# Access Compliance Report

## Public Rights-of-Way

### (Curb Ramps)

Intersection ID: 46818	Main Street: HOLM_OAK_PL	Cross Street: AZALEA_HILLS_DR	Location: W
ADA ID: 605DE4614FCB	Ramp Type: Perp	Initial Pass/Fail: Fail	Overall Compliance: No
Severity Score: 33.75			
Codes/Mitigation Info/Possible Solution		Field Measurements/Component Compliance

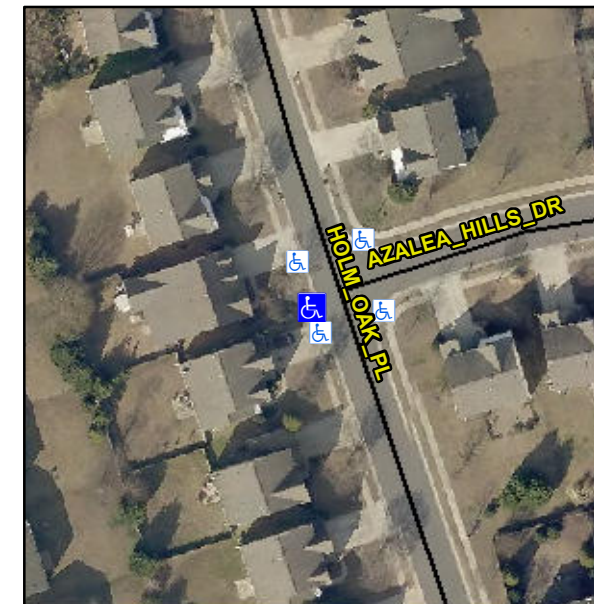
**R304.5.1, R304.2.2, R304.5.3**

Compliance	Description	Data	Compliance	Description	Data
N/A	Ramp Length (in)	47.0	No	Ramp Slope (%)	9.1
No	Ramp Width (in)	46.0	No	Ramp XSlope (%)	5.1
N/A	Flare Type LT	N/A	N/A	Flare Type RT	N/A
N/A	Flare Slope LT (%)	N/A	N/A	Flare Slope RT (%)	N/A
N/A	Flare Traversable LT?	N/A	N/A	Flare Traversable RT?	N/A
N/A	Landing Length (in)	N/A	N/A	DWS Provided?	N/A
N/A	Landing Width (in)	N/A	N/A	DWS Contrast?	N/A
N/A	Landing Slope (%)	N/A	N/A	DWS Length (in)	N/A
N/A	Landing X Slope (%)	N/A	N/A	DWS Full Width?	N/A
N/A	Landing Curb? (Y/N)	N/A	N/A	DWS Offset (in)	N/A
N/A	Shared Landing?	N/A			
N/A	Gutter Ponding?	N/A	N/A	Gutter Slope (%)	N/A
N/A	Gutter Lip Ht (in)	N/A	N/A	Gutter X Slope (%)	N/A
N/A	Painted X Walk1?	No	N/A	Painted X Walk2?	N/A
	X Walk 1 Direction	To E		X Walk 2 Direction	N/A
N/A	X Walk 1 Width (in)	N/A	N/A	X Walk 2 Width (in)	N/A
	X Walk 1 Slope (%)	3.2		X Walk 2 Slope (%)	N/A
	X Walk 1 X Slope (%)	3.3		X Walk 2 X Slope (%)	N/A

**Remove & Replace Entire Ramp.**
